Town of Kittery Planning Board Meeting November 8, 2018

459 U.S. Route One – Site and Subdivision Preliminary Plan Review

**Re: 459 US Route 1 - Kittery
Preliminary Plan Resubmission**

SHEET 1.1
 TAX MAP 60, LOT 24

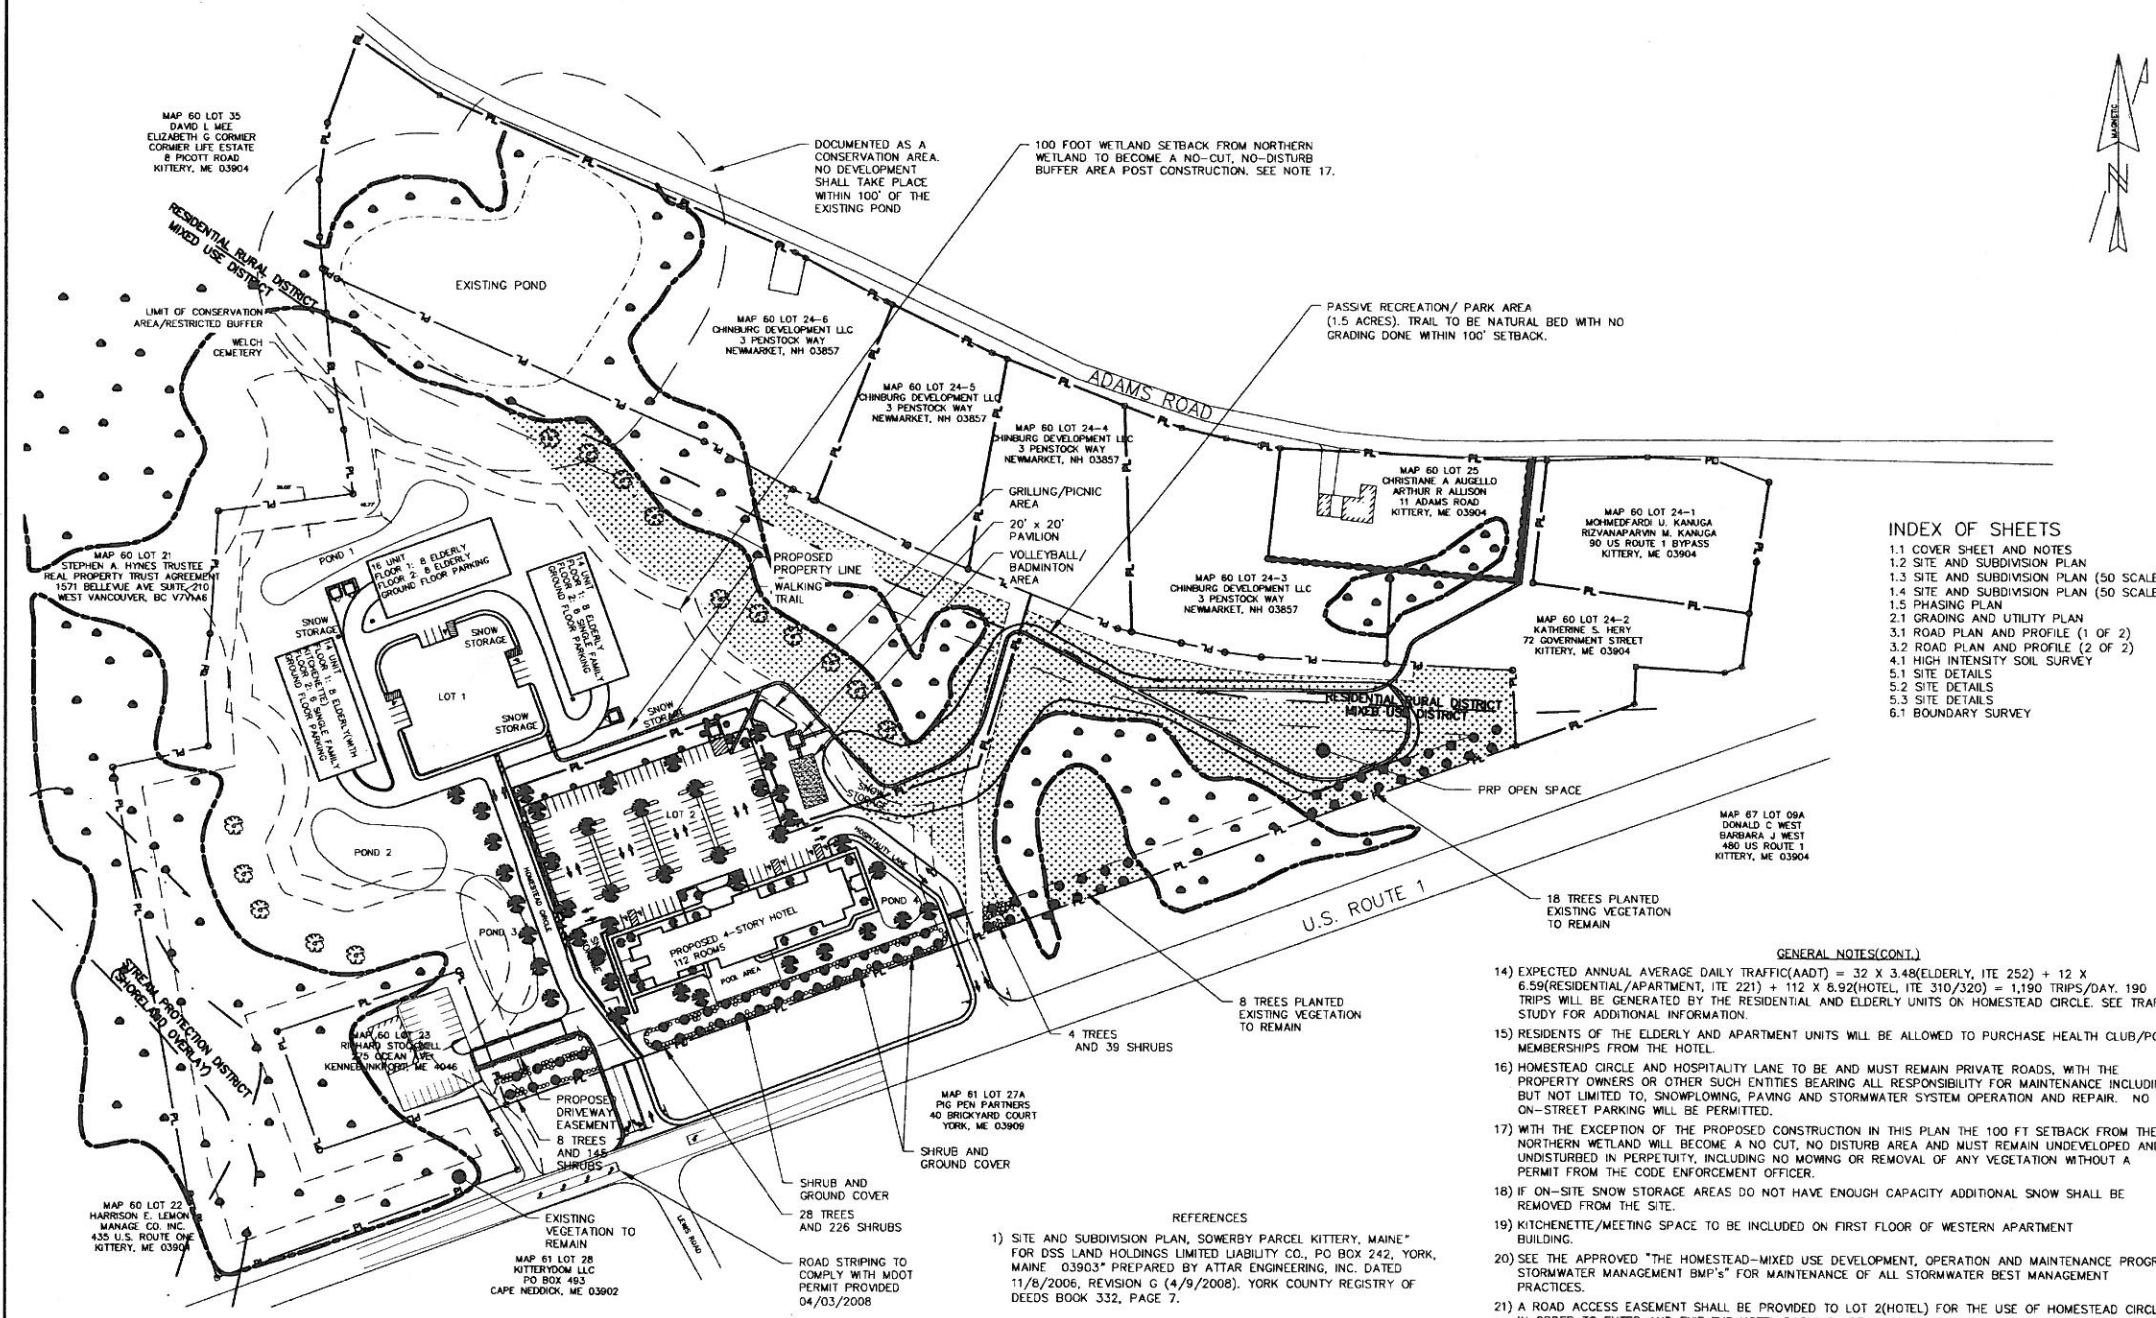
14. The arrow pointing to the 100 foot wetland setback from the northern wetland references Note 14 is inaccurate. It should reference Note 17 and Note 17 needs to be amended to state the following: "With the exception of the proposed construction in this plan the 100 foot setback from the northern wetland will become a no cut, no disturb restricted buffer area and must remain undeveloped and undisturbed in perpetuity, including no mowing or removal of any vegetation without a permit from the Code Enforcement Officer. This buffer shall be maintained with restrictions for the "No-Cut No-Disturb Restricted Buffer Area" as defined in the Declaration of Restrictions in the HOA documents.

1. Note 19 has been added to the Cover sheet. It states that a kitchenette/meeting space shall be included in the easternmost apartment building.
2. No-Cut, No-Disturb language has been changed on Note 17 to match Planner Review. Leader on Cover sheet that referred to Note 14 now refers to Note 17.
